566-594 Princes Highway, Kirrawee

RESPONSE TO SUBMISSIONS

Section 75W Modification (MOD 3)
to Concept Plan MP10_0076

Modification of Approved Envelopes (MOD 3)

Figure 1:

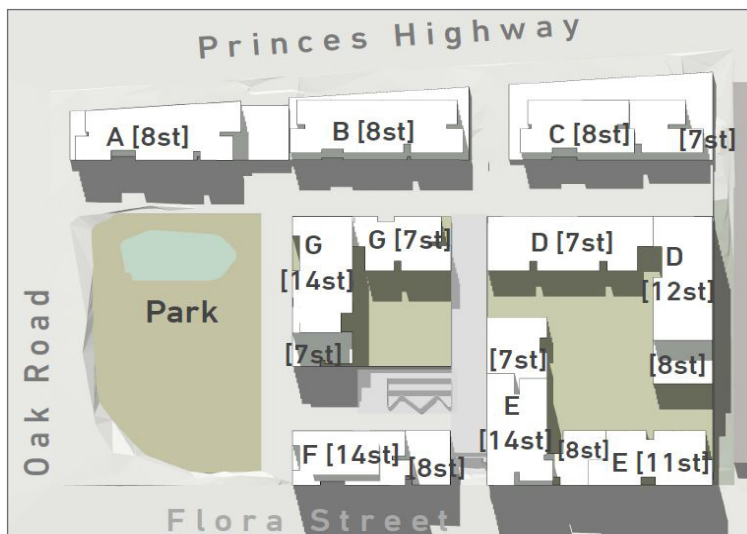
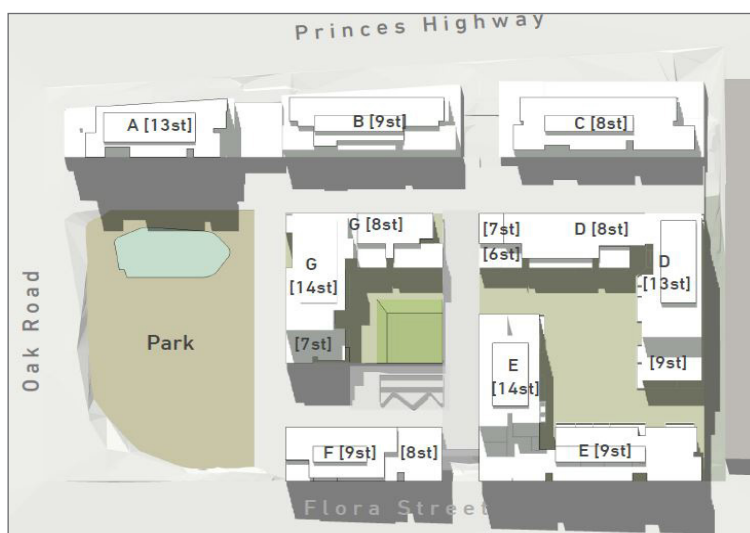
- reduction in height of Building F adjacent to Flora Street from 14/8 storeys down to 9 storeys;
- amendment to Building E to relocate the north-south 14 storey element from Flora Street to the north and a corresponding reduction in height from 14 storeys down to 9 storeys adjacent to Flora Street;

- increased separation of 1 metre for all buildings located adjacent to the eastern boundary to provide a minimum 9 metre setback from the eastern adjoining site;

Figure 2:

Amended S75W application
